SWCU-1 MODIFICATION for GPT-10K

KIT-161

DATE _____		. TMC SPECIFICATION NO. S 926	G
SHEET <u>2</u> OF <u>11</u>			
<i>LMM</i> COMPILED	CHECKED	TITLE: SWCU-1 MODIFICATION KIT (TMC NO. KIT 161)	
<i>JR</i> APPROVED

1. EQUIPMENT AFFECTED:
  - A. TMC MODEL GPT-10K general purpose transmitters.
2. PURPOSE:
  - a. Provides for a direct wattmeter reading in average power output and an indication of VSWR at the operated output of the transmitter.
  - b. Provides a 2:1 or 3:1 pre-set VSWR protective circuit overload and visual indicating device.
  - c. Provides for a single control ALDC adjustment.
3. MATERIALS SUPPLIED IN KIT:

FIG-#1

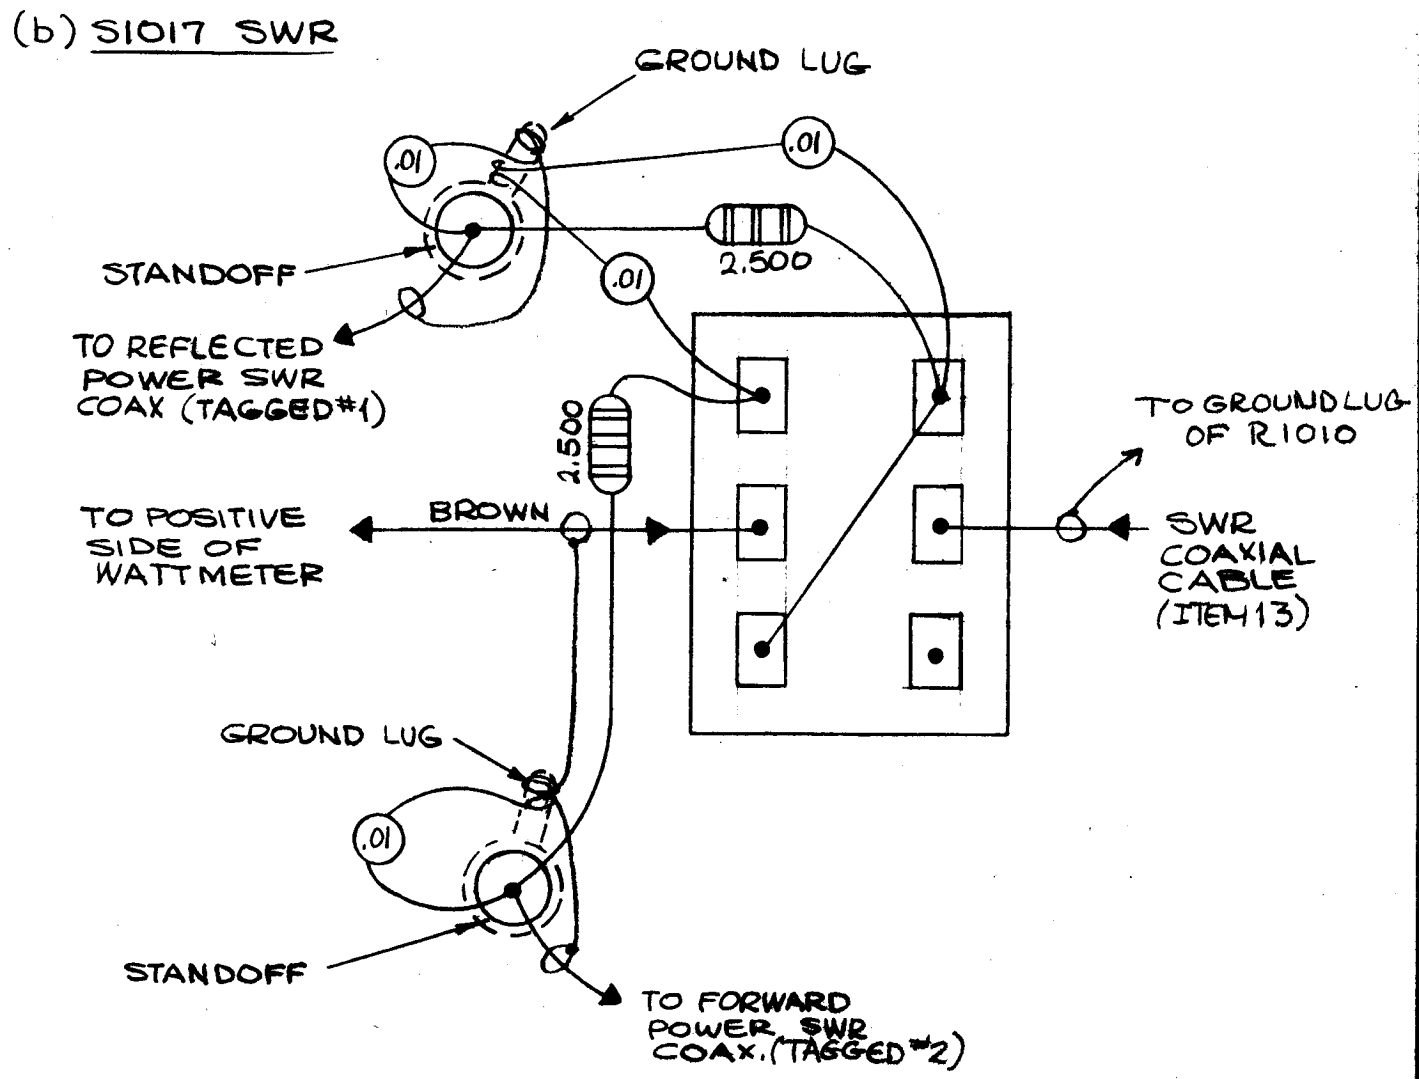
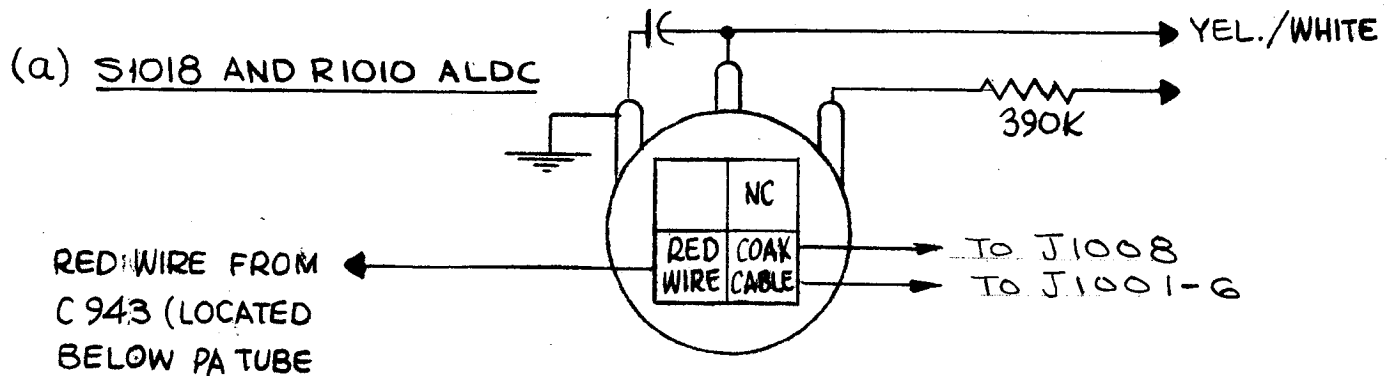
32. Attach item #21 supplied in kit, to shaft of item #7.
33. Connect CA-829 (item #10) cable, to newly installed items #6 and #7 as per Figure #1 'a' and 'b'.

45. Route coaxial cable from SWR, BNC connector on left side of Side Band Rack, through grommet hole, (right side, 4" from back of xmtr, on deck below main blower motor); through grommet hole, right side, behind RFC drawer: follow main frame harness, laying coaxial cable behind main power control panel up to SWR Switch located on Main Power Control Panel (S-1017). Lace the three loose, new, cables to main frame cable harness. **Wire per Fig. 1 (b).**

FIG-\*3

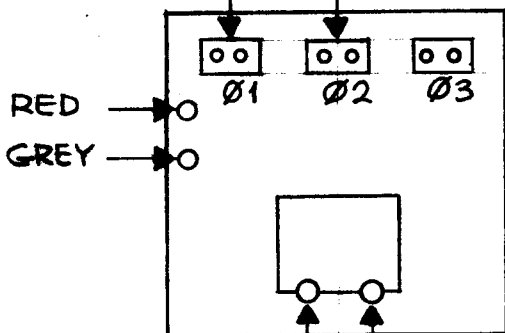
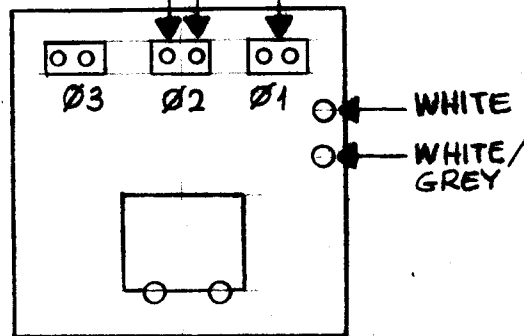
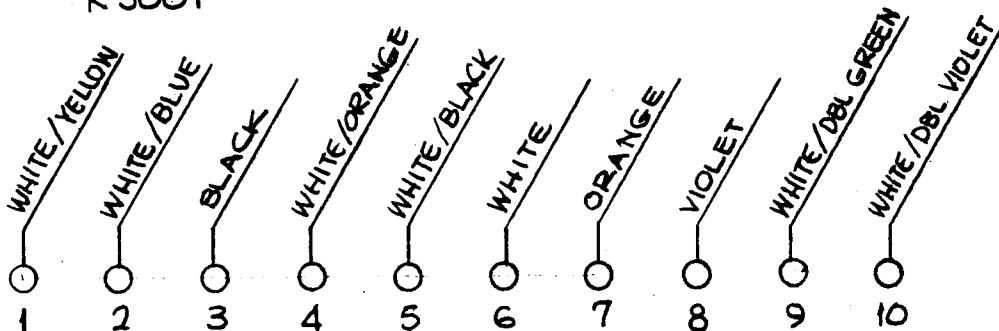
47. Replace step #46, removed cable assembly, with item #9 (CA-826) supplied in kit, rewiring according to Figure #3.
48. Install item #1 supplied in kit, directly below CPP-5, located at rear of Side Band Rack, with items #14 and #23 supplied in kit.

NOTE: ALL ABOVE WIRING IS IDENTICAL TO CABLE  
REMOVED IN STEP #46 OF MOD. KIT INSTRUCTION.
